TRANSMITTAL LETTER AND U S NAVY RESPONSES TO U S EPA REGION I COMMENTS
ON FINAL SAMPLING AND ANALYSIS PLAN DATA GAPS ASSESSMENT FOR TANK FARM
2 CATEGORY 1 AREAS SITE 10 NS NEWPORT RI
10/7/2013
TETRA TECH

Subject: Transmittal of Response to EPA Comments, Final Sampling and Analysis Plan
Tank Farm 2, Category 1 Areas
Site 10: Tank Farm 2, NAVSTA Newport, Rhode Island

**NAVY RESPONSES TO THE ENVIRONMENTAL PROTECTION AGENCY (EPA)
COMMENTS (AUGUST 15, 2013) ON THE FINAL SAMPLING AND ANALYSIS PLAN
(SAP), DATA GAPS ASSESSMENT, TANK FARM 2, CATEGORY 1 AREAS, NAVAL
STATION NEWPORT (NOVEMBER 16, 2012)**

FIGURE 2-2
 DEFENSE FUEL SUPPORT POINT MELVILLE
 PORTSMOUTH, RHODE ISLAND
TANK FARM 2
PCB SAMPLING LOCATIONS
 SCALE: AS SHOWN

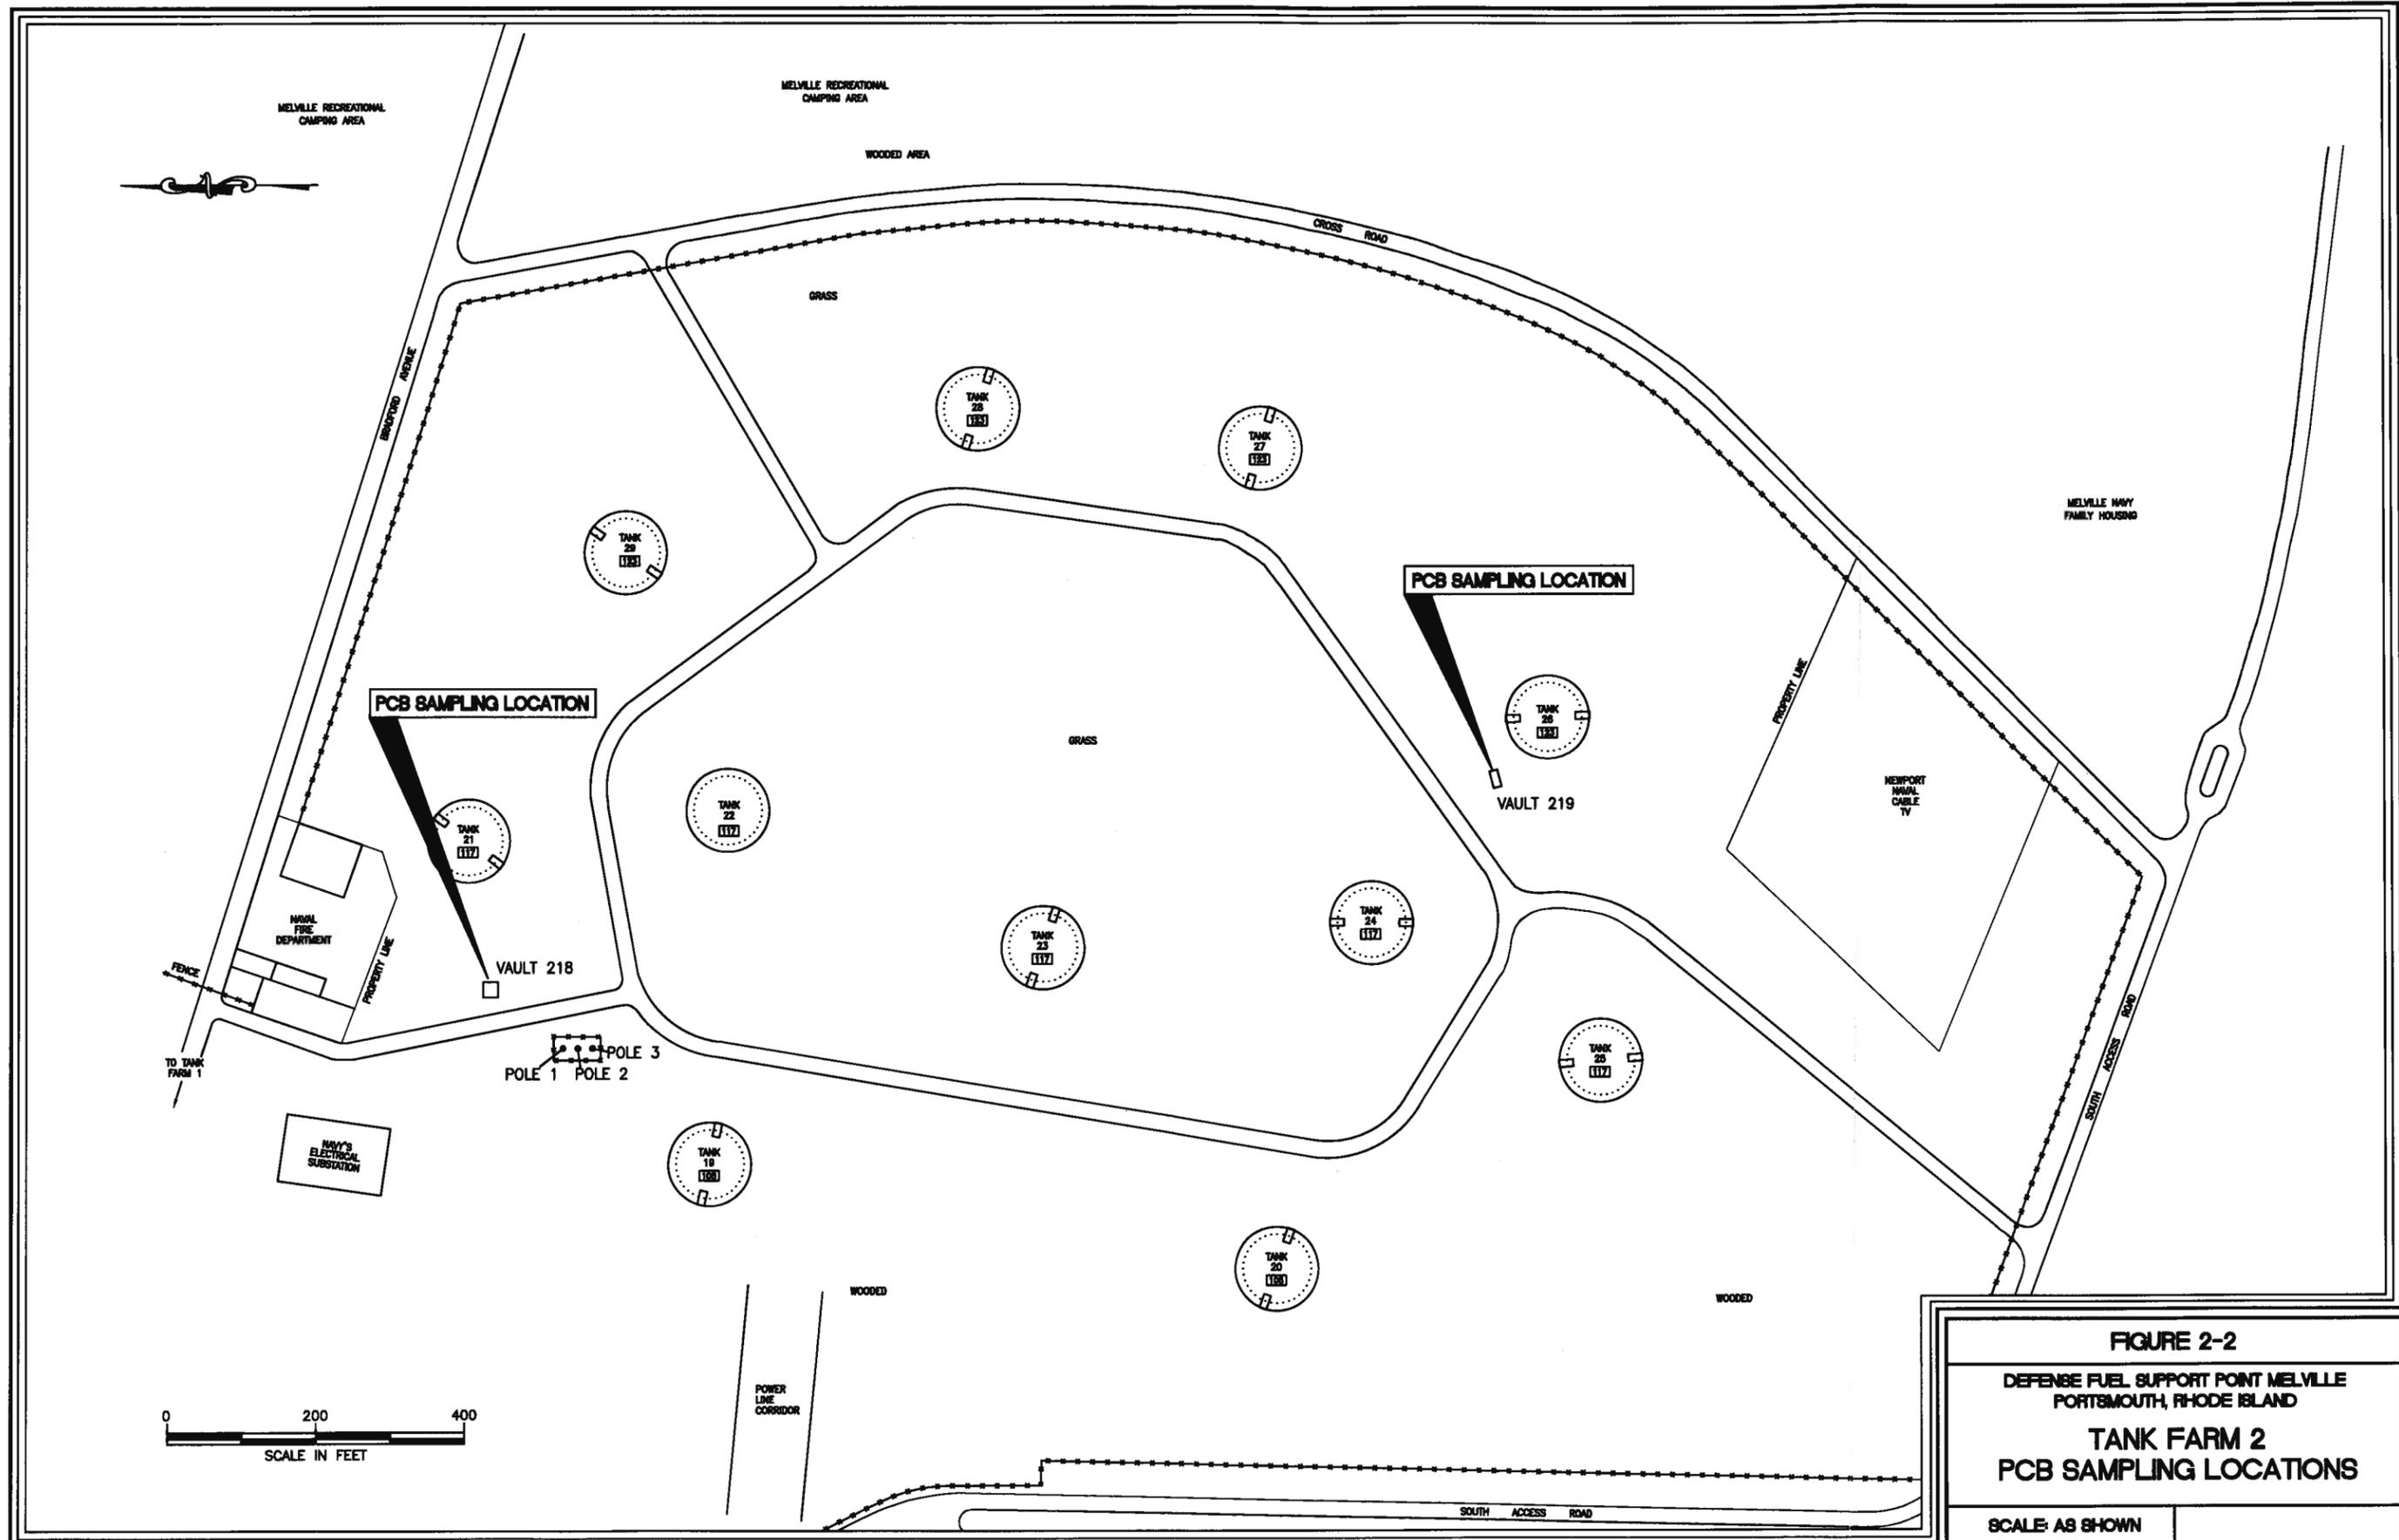
EPA General Comment 1: Please clarify where Building 218 is located and why it was not investigated. EPA previously requested that the area around this building be sampled for PCBs and lead.

Navy Response: Building 218 is located about 200 feet west of Tank 21. Figure 2-2 from the SIRAR is included and it shows the location. RIDEM had requested additional investigation of Building 218 and the following was provided to RIDEM and EPA on 11/15/2011:

"The investigation at Building 218 included the collection and analysis of fourteen shallow soil (0' to 0.5' bgs) samples around the building. Seven of the samples were analyzed for PCBs and chlorinated benzenes. Eight of the samples were analyzed for lead. Attached is a field form from the sampling and analysis that shows the locations of the soil samples and it should be noted that all of the samples taken in close proximity to the battery pack storage area and six of the seven PCB/ chlorinated benzene samples were collected in close proximity to the transformer. The results of the analyses are presented on the attached table. PCB/ chlorinated benzenes were not detected in the samples. This indicates that PCBs have been investigated and there has not been a release in of PCBs in the vicinity of Building 218.

Lead was detected in all of the samples at concentrations below the ICDEC of 500 mg/kg. Seven of the eight samples contained lead at concentrations below the RDEC of 150 mg/kg. One sample (collected from the north side of the battery backup area) contained 200 mg/Kg lead, above the RDEC criteria of 150 mg/Kg. The lead concentrations are well below the EPA residential RSL of 400 mg/Kg. The average concentration of lead in soil samples collected in the vicinity of the battery storage area is 76 mg/kg, well below the RDEC of 150 mg/kg. Furthermore, as shown on the field form that depicts the locations of the soil samples, the extent of the RDEC exceedance is of limited extent. The magnitude and extent of lead in soil around B218 does not indicate a release of lead from the battery storage area. Therefore, Navy has completed the investigation with respect to a possible release of lead in the vicinity of Building 218."

Figure 3

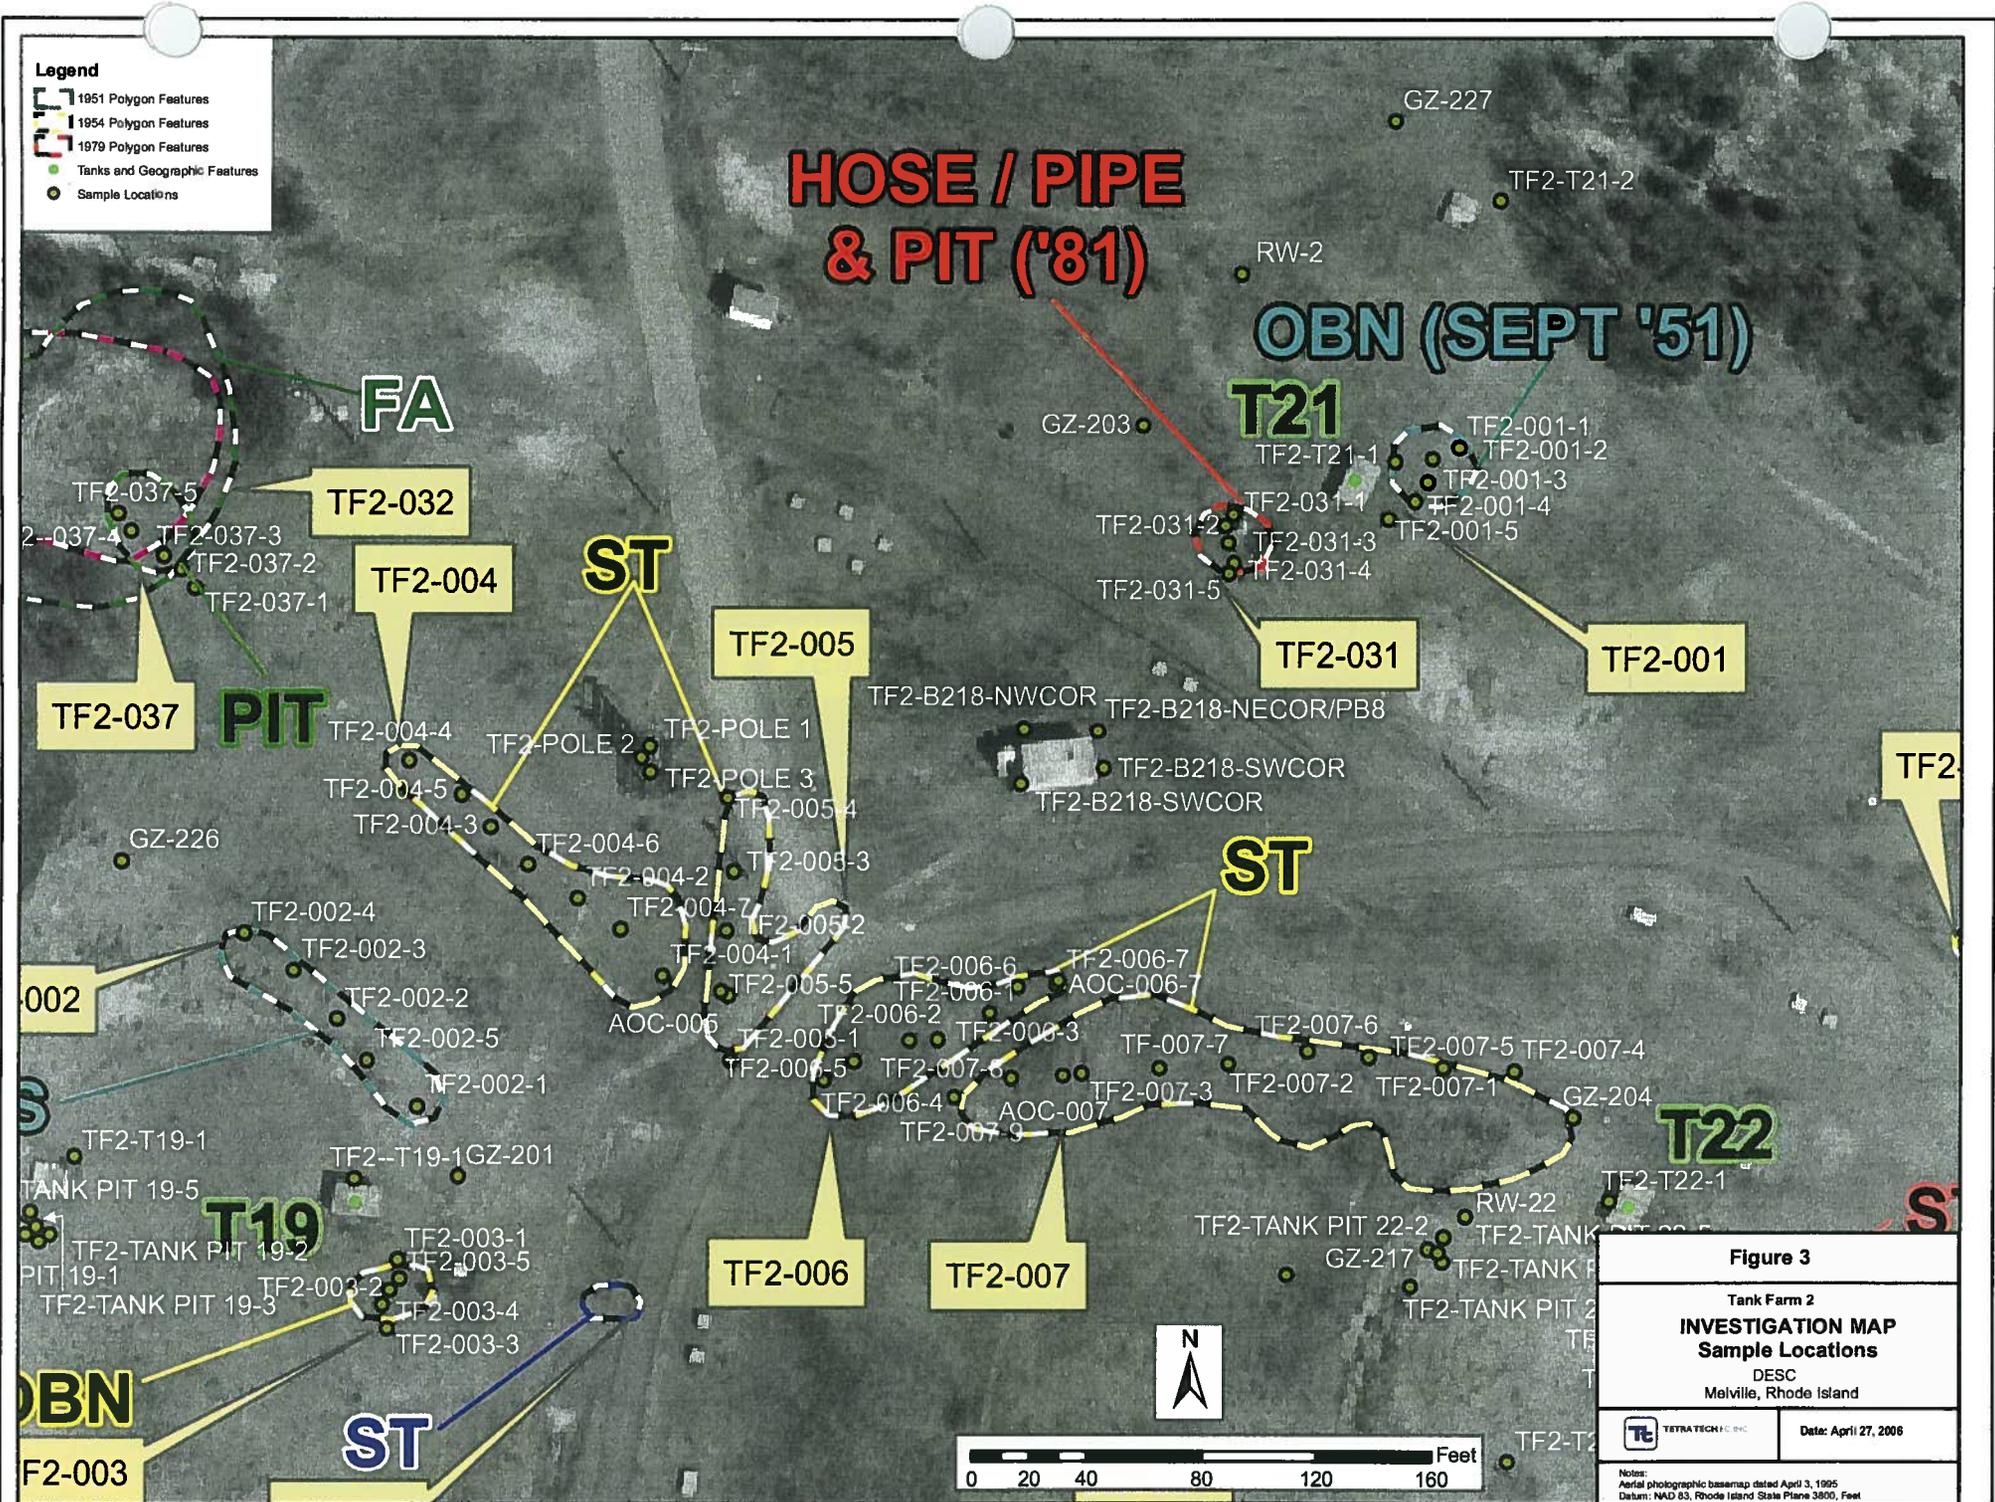
EPA General Comment 2: Figure 2 and 3 depict different locations of Site features, including the Areas of Concern (AOCs) 001 and 003. How did the Navy locate those AOCs? Which figure shows the correct locations? Please provide the supporting documentation (GPS or survey data; aerial photographs; etc.) for the locations of all four AOCs and relevant Site features. Please provide the July 2006 SIRAR (including the April 2009 Addendum 1), as it is not available on the Navy's on-line Administrative Record.

Navy Response: Figure 3 of the SAP shows the correct locations of AOCs 001 and 003. Figure 3 was created by taking the data from the SIRAR. Figure 3 from the SIRAR is attached. This figure shows AOC-001, AOC-003, AOC-004 and AOC-005 overlaid on an aerial photograph. The 2006 SIRAR will be forwarded to the EPA. The 2009 Addendum will be forwarded too. Please note however, that the 2009 Addendum is a report on a soil treatment pilot test performed for TPH-impacted soil and has nothing in it that is relevant to this SAP.
